**SUBJECT: Westinghouse Owners Group Comments on Proposed NRC Bulletin 96-01
Supplement; Control Rod Insertion Problems Notice of Opportunity for Public
Comment (62 Fed. Reg. 27629) (Proprietary)**

Westinghouse Owners Group
Comments on Proposed NRC Bulletin 96-01 Supplement
Westinghouse Non-Proprietary Class 3

The purpose of this document is to provide the Westinghouse Owners Group (WOG) comments, exceptions and recommendations regarding the Draft NRC Bulletin 96-01, Supplement 1: Control Rod Insertion Problems.

Figure 1: RCCA Rod Drop Tests

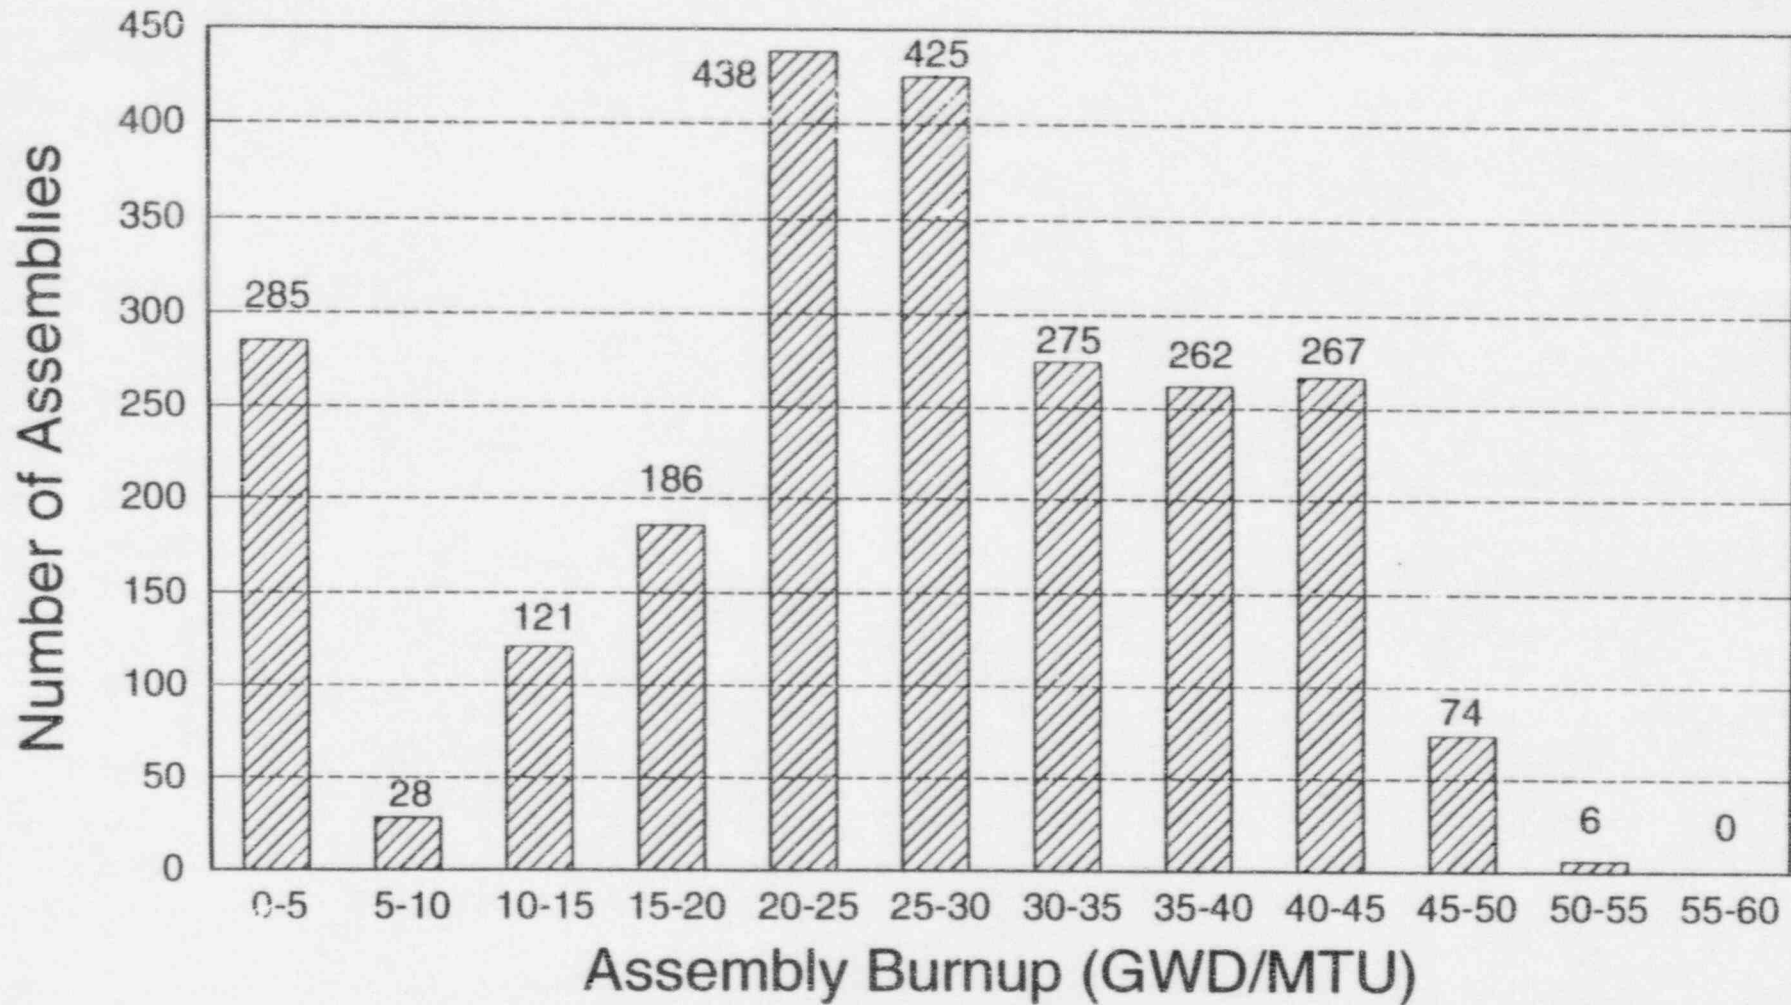
As stated above, a significant amount of testing and monitoring has been conducted by WOG member utilities and Westinghouse in response to Bulletin 96-01. Figure 1 provides a summary of recent RCCA rod drop tests in WOG member plants utilizing 12 ft. and 14 ft. fuel with burnups ranging up to 54,900 MWD/MTU fuel assembly average. These results are from rod drop tests at 32 different plants having a total of 2766 RCCA insertions. Figure 2a to 2c contain the drag data from 23 different plants for a variety of different fuel designs: 14x14OFA, 15x15OFA, 17x17XL, 17x17IFM, 17x17non-IFM, for a total of 1390 fuel assemblies tested. This huge experience base from hundreds of rodged fuel assemblies demonstrate the validity of the Wolf Creek root cause and the highly unusual nature of this experience.
